SVP-98-345

Quad Cities Nuclear Power Station, Units 1 and 2
Facility Operating License Nos. DPR-29 and DPR-30
NRC Docket Nos. 50-254 and 50-265

Subject: **Response to NRC Request for Additional Information for
Technical Specification Change Request**

ATTACHMENT
RESPONSE TO REQUEST FOR ADDITIONAL INFORMATION
SVP-98-345
(Page 1 of 15)

FIGURE 1
 "MAIN STEAM PIPING SYSTEM"
 SVP-98-345
 (Page 1 of 1)

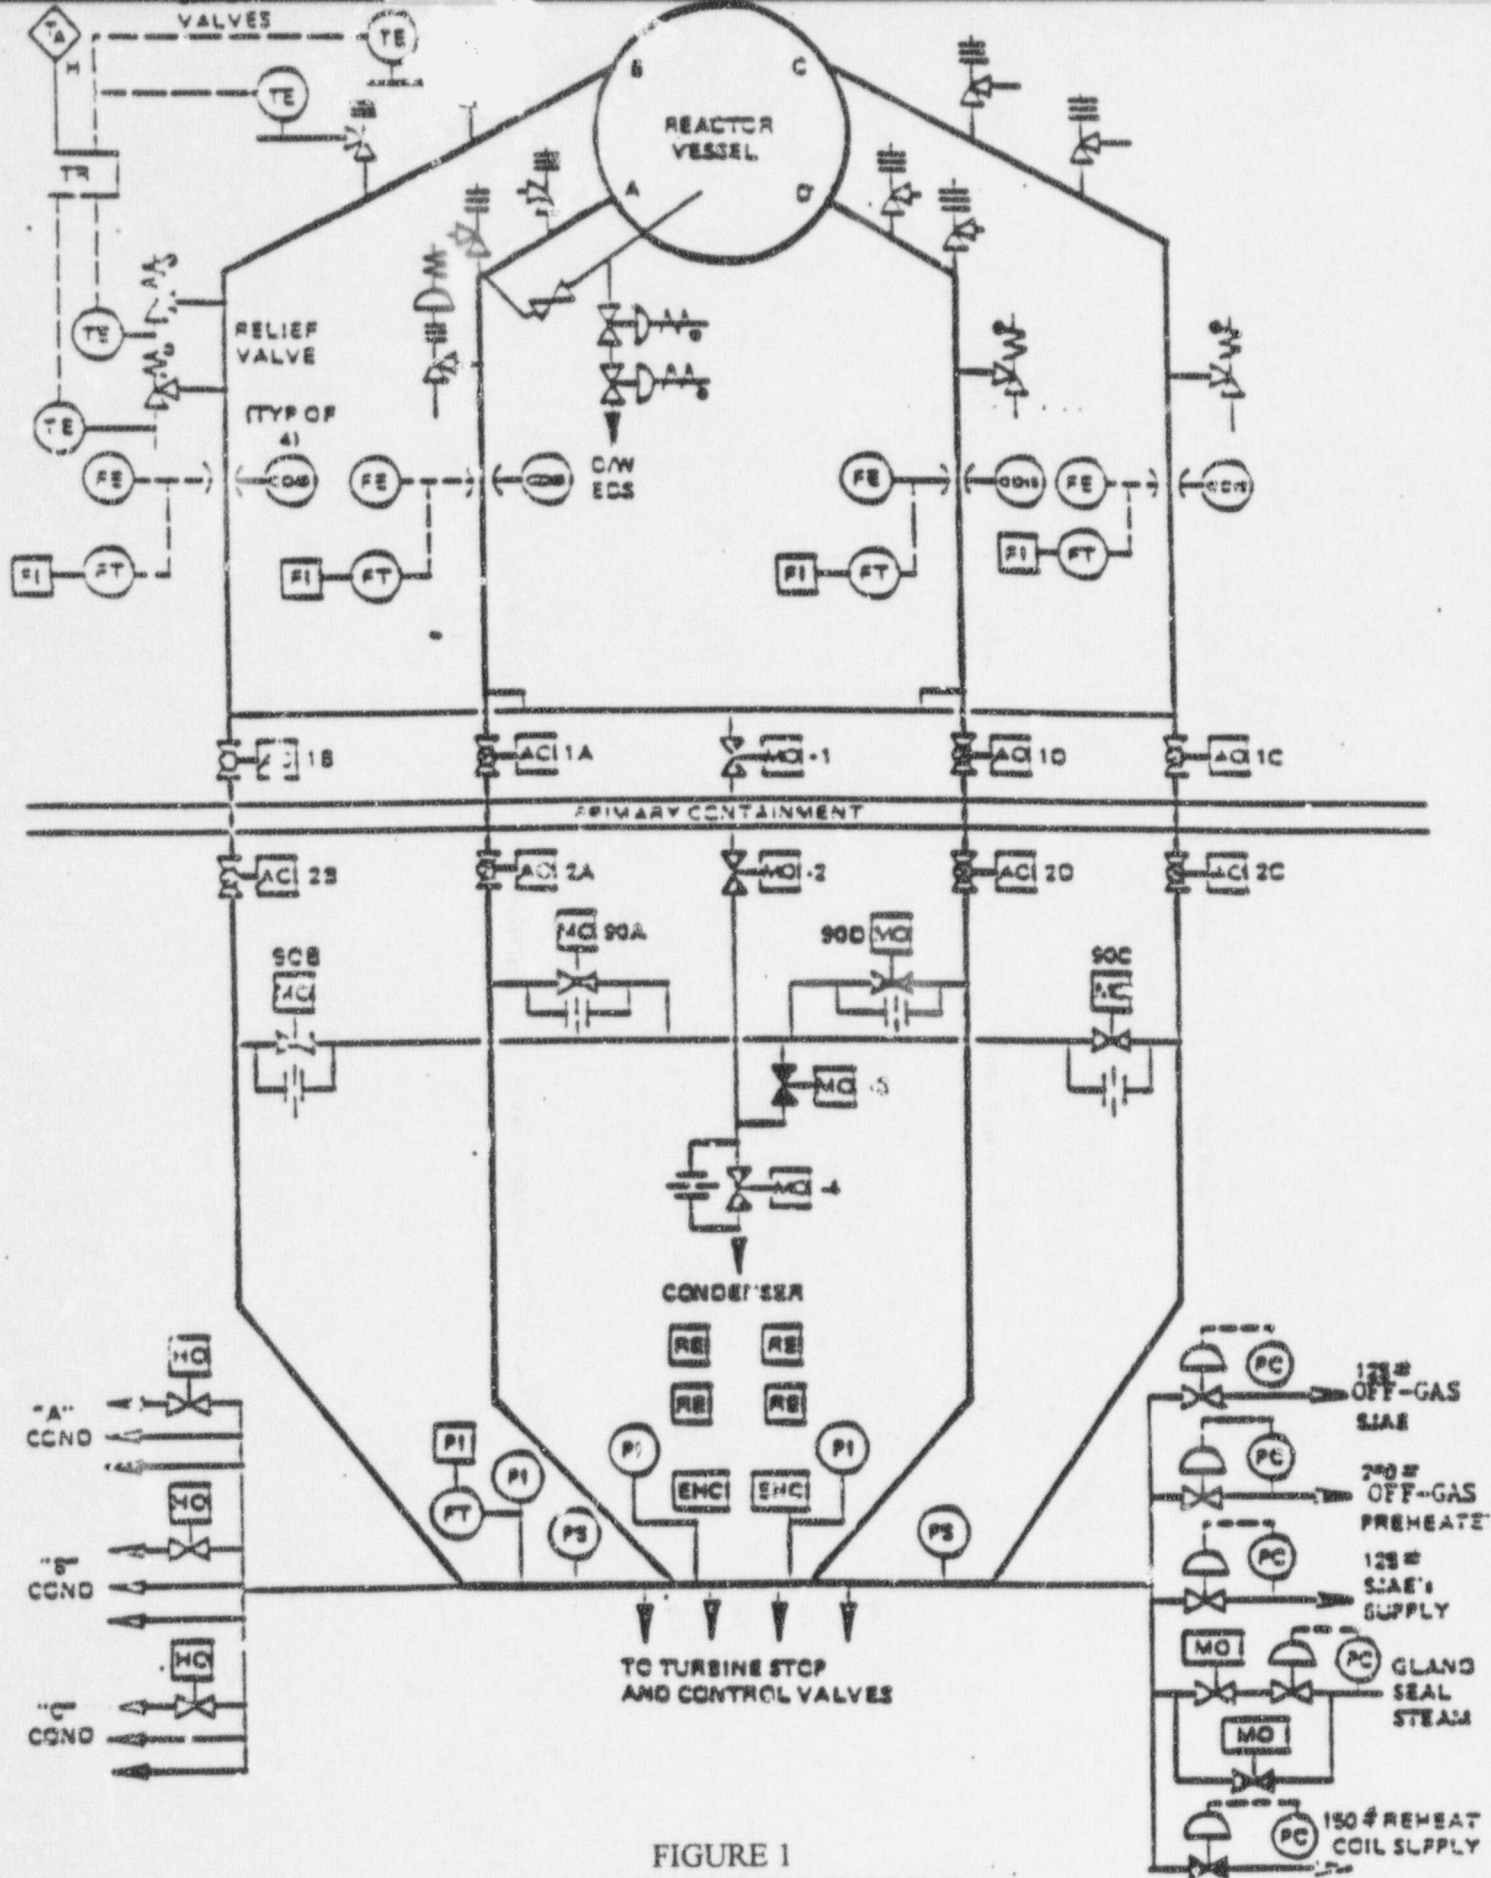
8. *The licensee is requested to address the reliability of the entire leakage treatment path, including all of its boundary valves. This may include descriptions and diagrams of the Intended leakage treatment path and boundaries, and assurance that valves required to open the leakage treatment path to the condenser are provided with a highly reliable power source. In addition, confirm that valves which are required to open the leakage treatment path to the condenser will be included as part of the plant inservice testing (IST) program with appropriate testing interval.*

Following a LOCA, four potential pathways exist for any leakage past the MSIVs. For more information, please refer to enclosed figure 1, "Main Steam Piping System." ComEd considers the Main Steam Drain Piping (pathway No. 4 below) as the mitigation pathway to the Main Condenser.

- 1) Main Steam Piping to the High Pressure Turbine, through the High Pressure Turbine seals to the environment, bypassing the Main Condenser.

MSIV leakage through the Main Steam Piping to the High Pressure Turbine is not considered credible. The MSIV leakage would have to pass through the Main Turbine Stop and Control valves before reaching the high-pressure turbine (bypassing the Main Condenser). The Main Turbine Stop and Control valves are designed to close following a design basis LOCA event (normal response following a reactor shutdown). These valves are highly reliable as would be required, if these valves were within the IST program scope, each valve is exercised periodically in accordance with the manufacturer recommendations, approved station procedures and Technical Specifications (Table 3.1.A-1, Reactor Protection System Instrumentation).

2) Main Turbine Bypass to the Main Condenser with delayed release to the environment through the Low Pressure Turbine seals.

MSIV leakage through the Main Turbine Bypass Piping to the Main Condenser is not considered credible. The Main Turbine Bypass Valves are designed to close following a design basis LOCA event (normal response following a reactor shutdown and MSIV closure). These valves are highly reliable as would be required, if these valves were within the IST program scope, each of the Main Turbine Bypass Valves is exercised periodically in accordance with the manufacturer recommendations and approved station procedures. This testing provides reasonable assurance that the Main Turbine Bypass Valves are functional and will close following a design basis accident.

3) Auxiliary Steam Loads (delayed or treated release to the environment)

4) Main Steam Drain Piping to the Main Condenser with delayed release to the environment through the Low Pressure Turbine seals.

The Main Steam Drain Piping to the Main Condenser pathway is the existing pathway that may be credited as an iodine treatment mechanism to reduce the radiological consequences of a LOCA. This existing flow path from the Main Steam Drain Piping to the Main Condenser requires repositioning of Main Steam Drain Valve 220-03 which is powered from the Class 1E Essential Service Motor Control Center 18-1 and utilizes the existing orificed line, bypassing the closed 220-04 valve to provide a pathway to the condenser.

The 220-03 valve is not currently included in the Quad Cities ISI or IST programs. ComEd commits to develop an appropriate test program to ensure reliability of this valve.
